Subject: Carlsbad Field Office Class 1 Permit Modification Notifications to the Waste Isolation Pilot Plant Hazardous Waste Facility Permit Number: NM4890139088-TSDF

**Class 1 Permit Modification Notifications**

**Update Property Protection Area Fence Line to Incorporate Temporary Fence Changes and Update WIPP Emergency Evacuation Figures and Text**

**Waste Isolation Pilot Plant  
Carlsbad, New Mexico**

Figure D-5  
Fire-Water Distribution System

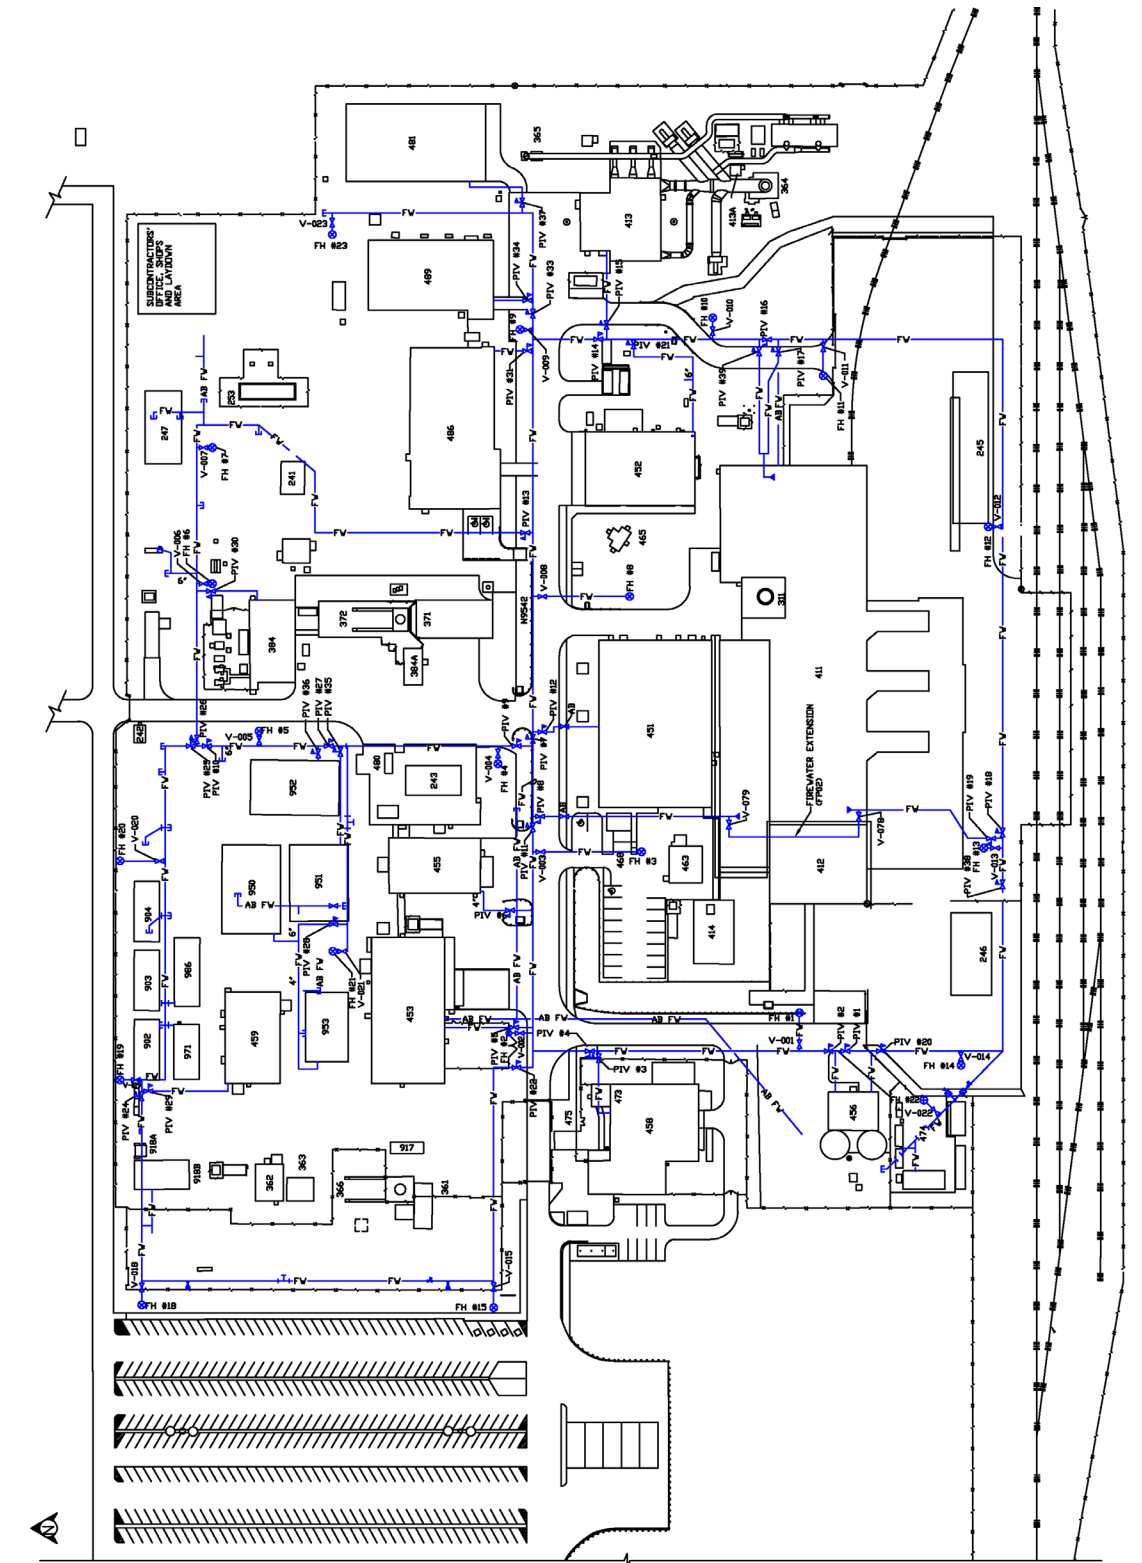
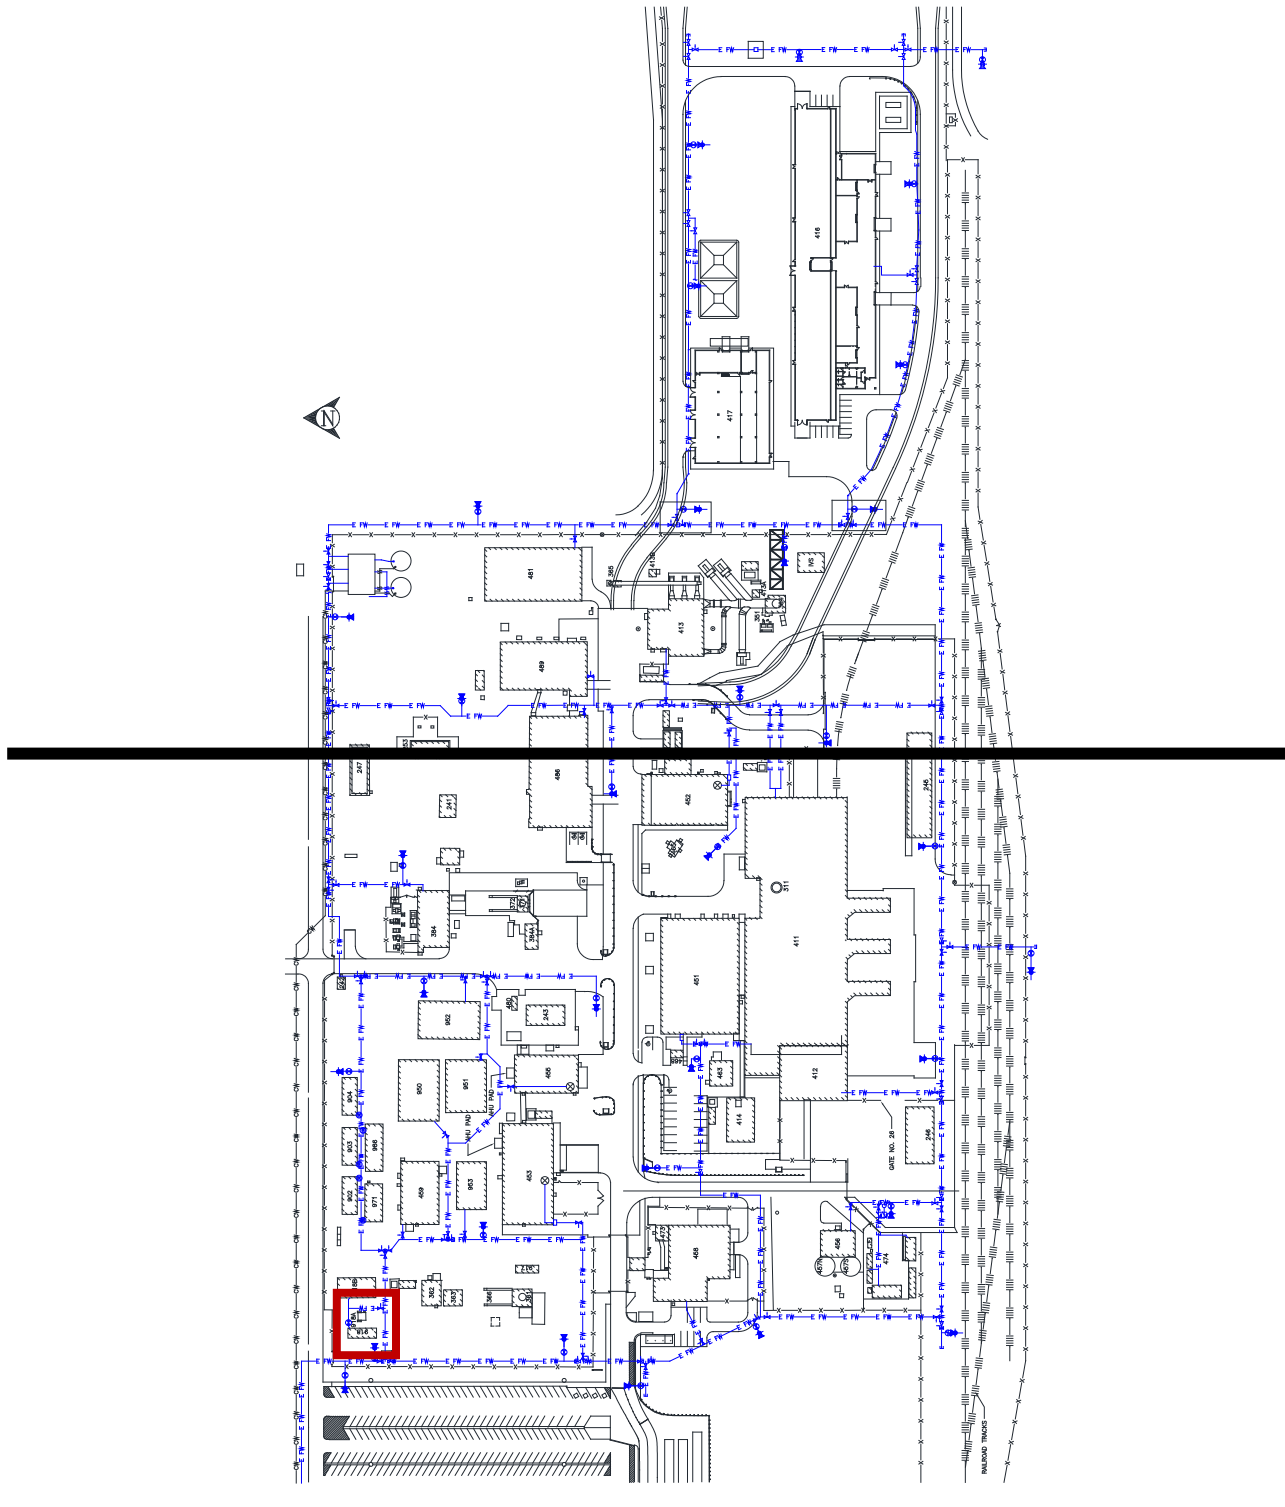
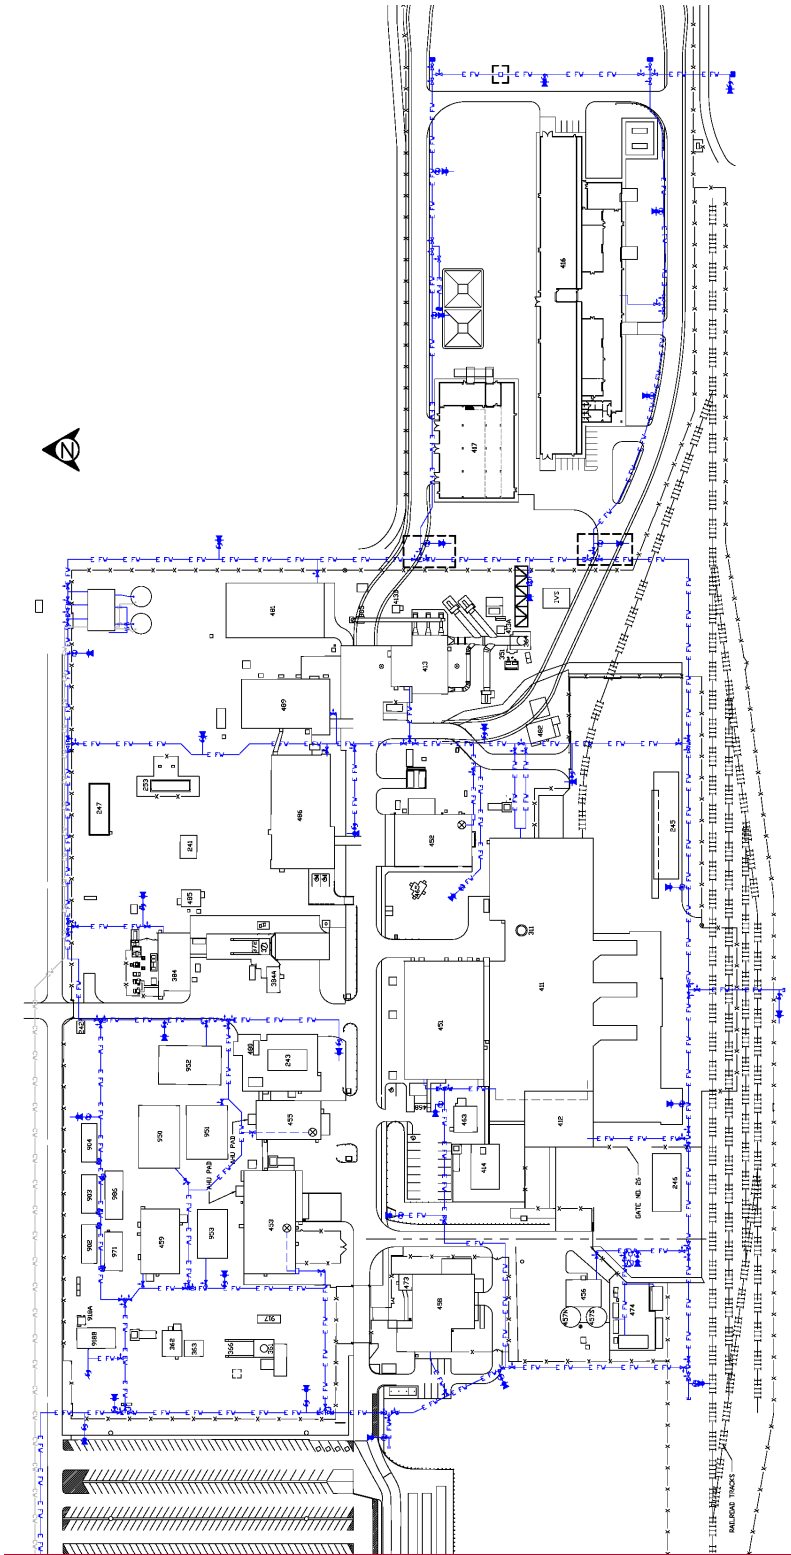
- Attachment A4, Figure A4-2, *WIPP Traffic Flow Diagram*
- Attachment D, Figure D-1, *WIPP Surface Structures*
- Attachment D, Figure D-5, *Fire-Water Distribution System*
- Attachment D, Figure D-6, *WIPP On-Site Assembly Areas and Off-Site Staging Areas*

- Attachment D, Figure D-5, *Fire-Water Distribution System*
- Attachment D, Figure D-5-NFB, *Fire-Water Distribution with Building 416*
- Attachment D, Figure D-6, *WIPP On-Site Assembly Areas and Off-Site Staging Areas*
- Attachment D, Figure D-6-NFB, *WIPP On-Site Assembly Areas and Off-Site Staging Areas with Building 416*

**Figure D-8a**  
**WIPP Site Evacuation Routes**

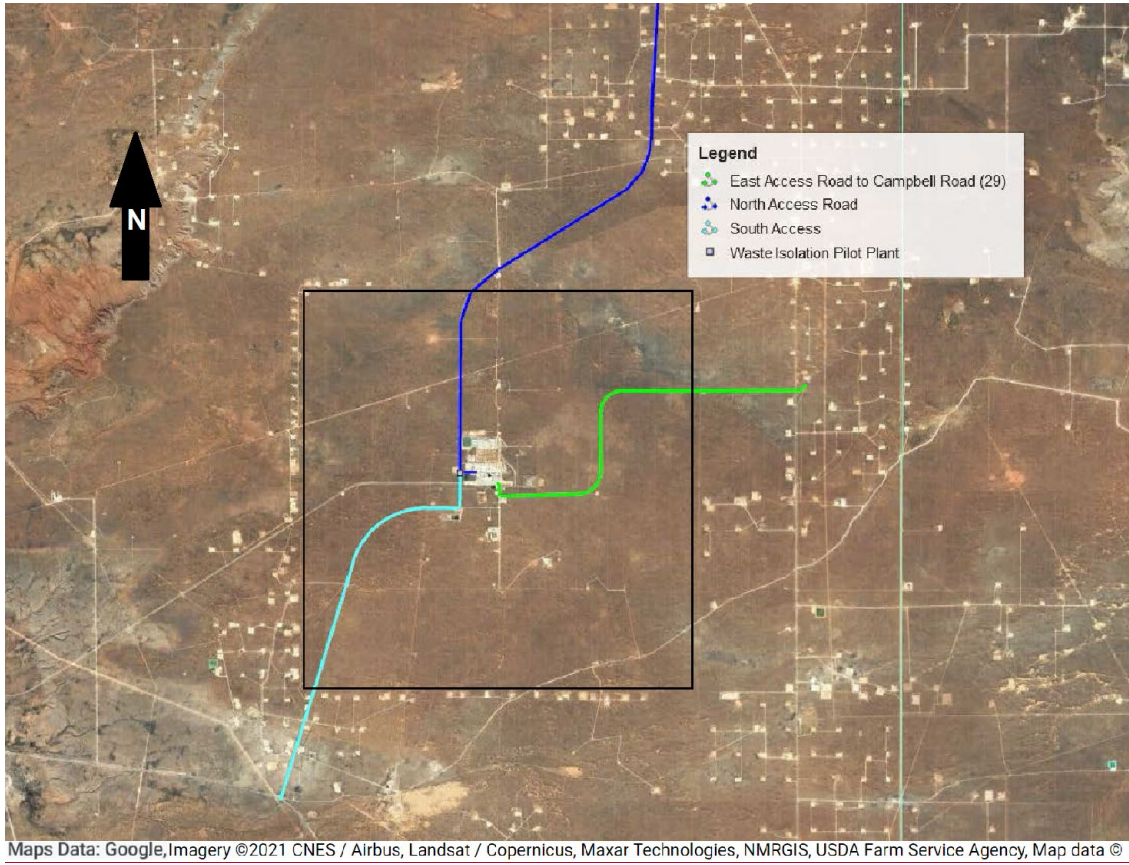
- Replaces Figure D-8 with updated figure incorporating directional north arrow
- Changes Figure D-8 *WIPP Site Evacuation Routes* title to *WIPP Site Evacuation Map*
- Adds Figure D-8a, *WIPP Site Evacuation Routes* to reflect and incorporate recent changes to implementing documents of the *WIPP Emergency Management Plan*
- Updates the Permit text in Sections D-8a, *Surface Evacuation On-site and Off-site Staging Areas* and D-8e, *Further Site Evacuation*, to clarify emergency event evacuation and figure references
- Adds Figure D-8a *WIPP Site Evacuation Routes* to the List of Figures

In addition to the changes due to the temporary barrier construction, Figure D-8, *WIPP Site Evacuation Routes* has been replaced with an identical figure incorporating a directional north arrow and renamed *WIPP Site Evacuation Map*. Figure D-8a, *WIPP Site Evacuation Routes*, has been added to Attachment D to be consistent with the current implementing documents contained in the *WIPP Emergency Management Plan*. Figure D-8a is a satellite image depicting the WIPP site and highlighting the evacuation roads for further site evacuation. These changes are needed to ensure consistency between the Permit and the current *WIPP Emergency Management Plan* implementing documents.
